# RAPID ASSESSMENT OF ZALUN BANK EROSION (DRAFT)

field inspection, diagnosis and first recommendations

RVO in collaboration with DWIR

8 FEBRUARY 2020

Figure 13: Barrels in triangular formation (top left); Stacked Barrels (bottom left; right); Overview of the barrel measure (middle).

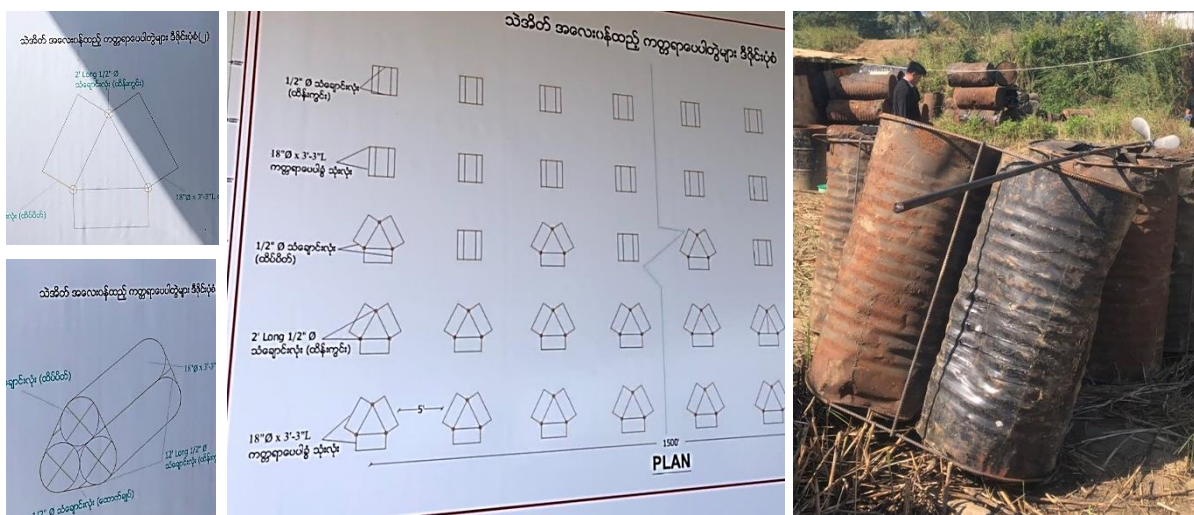
The outer-bend erosion protection (A), referred to as the barrel measure hereinafter, consists of old (rusty) barrels that are filled up with sand using polyethylene woven bags. The barrels are either placed in a triangular formation or are stacked on top of each other (Figure 13, left). Subsequently, the barrel-constructions are placed at 5 feet intervals (10 feet spacing if measured from centre to centre) and are fixed at the head of the slope around a wooden pole (Figure 13, middle). The downslope situated barrel constructions are attached to the topmost barrels using thick ropes, this prevents the barrels to shift downward during the (monsoon) flows and aims to optimize the slope protection.

Whereas the applied barrel measure is possibly the only possible measure given the limited budget (said to be 30.000 USD), the local DWIR staff indicated that some barrels were found at the toe of the slope, hence the protection measure might not last throughout the full wet season.

Additionally, considering the use of sparsely distributed protection elements (the barrels), rather than full slope covering protection works (such as revetments), one could argue that the subsequent flow turbulence around the barrels could worsen the slope stability. However, following soil sampling of the river bed and bank during the field inspection (Figure 14 and Appendix B), various silt/clay layers were found indicating that the impact of turbulence might be limited as compared to dominant sand-bed river systems.

Therefore, the Zalun riverbank erosion prevention requires - apart from careful preparation and implementation - extensive and effective monitoring and surveying so to keep track of whether the barrel construction remain in place throughout the wet season. This could be realized by multi-beam surveying. Effective surveying and bathymetric analysis will allow DWIR to better cope with the unpredictability inherent to major river systems. This is especially relevant as in monsoon dominated river systems, where the difference between dry season and wet season flows is significant, designs and planning can only be realized one year at a time, i.e. what is built in year one, will change the river morphology in year two. Hence the design for riverbank protection in year two can only be made once the response to the year one construction is visible, measured and presented. This asks for a more adaptive approach towards river engineering works.

Figure 16 The possible erosive attach on the Zalun west bank following the new excavated canal

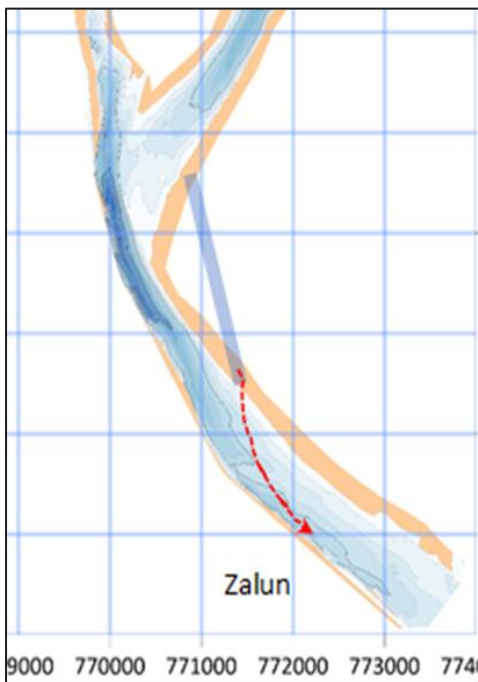
The impact of the new channel is not certain. In the wet season the sand bank will be flooded and flow will go over it most likely under an angle with the dredged new channel. Given the expected high sediment transport rates (which is proven by the rapid growth in the past of the whole sand bank) and the relatively small dimensions of the newly dredged channel, it is likely that the new channel will completely silt up during the wet season. In addition to this it is also likely that on both ends of the new channel strong sedimentation

will block the in- and outflow which will accelerate the abandonment of this new channel. As such, therefore, it is unlikely that the new channel (intervention B) will have much impact on reducing the flow velocities near the river’s west bank or near Zalun.

If, on the other hand, the new channel would indeed attract flow and play a role in the river run-off, then the new channel may also develop into a larger river channel. And if that happens, then a portion of the river discharge will be directed towards the westbank at Zalun, in theory worsening the local safety situation (Figure 15 – left, and Figure 16).

We consider the current dredging of the channel through the east sand bank not desirable because (i) we expect the channel to silt up soon after its construction in the first months of the wet season, or in contrast (ii) the event that the channel does become a significant flow channel, this channel may further aggravate the erosion at the Zalun bank as more river discharge will approach its west bank more directly. As an alternative option, it may be considered to remove the current vegetation on the flood plain/sand bank on the east and to lower it with say 2 m. This gives another 2000 m<sup>2</sup> cross-sectional flow area which is significant compared to the cross-sectional flow areas presented in Table 1 (between 5000 and 6000 m<sup>2</sup>). Note that the flow resistance will be higher due to shallower depths, but nevertheless it can be expected that it has a noticeable impact on the flow distribution on the short term. If the quality of the sand is good enough, this sand can also be removed from the river system and sold to compensate for the costs via a Public Private Partnership (PPP). The advantage of such eastern bank modification is that water from the upper cut-off channel can flow over it more easily (decreased flow resistance) and enter the main channel more gradually thereby decreasing the impact of erosive attack on the west bank near Zalun as it may lower the flow velocities directed under an angle towards the west bank.

Figure 18 summary of proposed alternative options

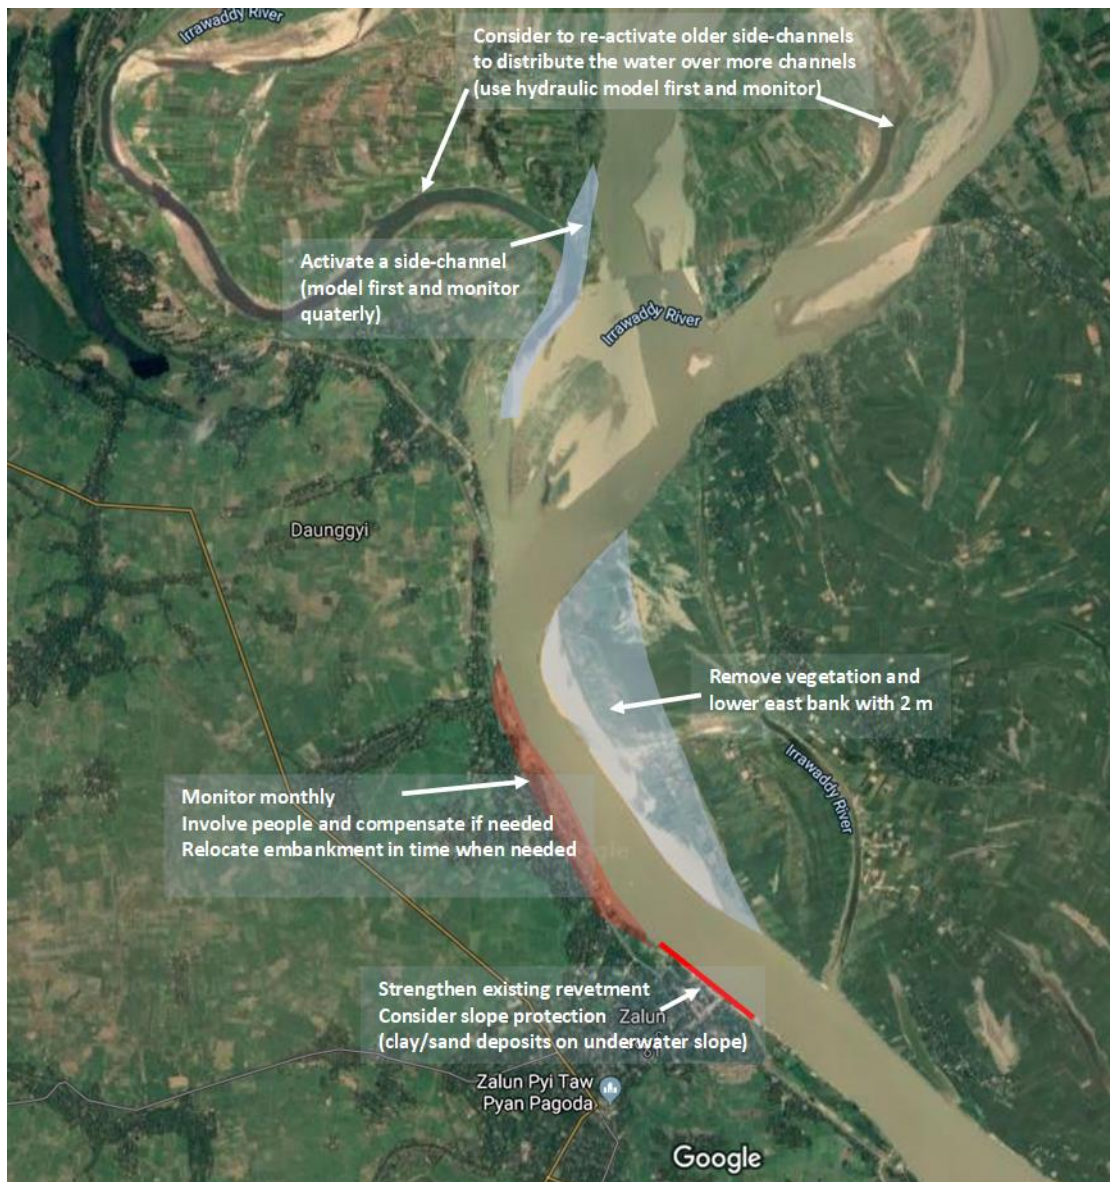
The first, and foremost most important measure that should be taken is the rehabilitation of the failed revetment near Zalun so that the coming 2020 flood season does not deteriorate the current situation. Best option to do this is by covering the failed revetment works with sand-filled geobags. This is a cost-effective solution given the required urgency. In the long run a strong revetment at Zalun, built both above and under water with a sufficiently long falling apron, is the only way to stop the local bank erosion. However, it is hardly possible to build (17 m deep and 8 m high with already very steep slopes 1:2) and it will be very expensive (estimated at least 6000-10000 USD/m). In case the latter would be preferred in the long run, it is uncertain whether such a project has a feasible cost-recovery which implies that the avoidance of (monetary) damage to be larger than the costs for preventing this damage. We are not convinced this to be the case at Zalun.

Whereas a revetment in front of Zalun may be considered, constructing such expensive bank protection measure for the largely agricultural area north of Zalun is not anticipated to be cost-effective. Here, the economic value of the hinterland and its households is not likely to balance with the cost of potential avoidance of damage. This is related to the fact that the area comprises mostly out of agricultural areas and smaller community villages.

Whereas the above measures are potential game changers effective in the short run, the other proposed measures as depicted in Figure 18 will help resolve the current threats in the long run. Hereto, it is pivotal that the river gains more space in both horizontal and vertical direction.
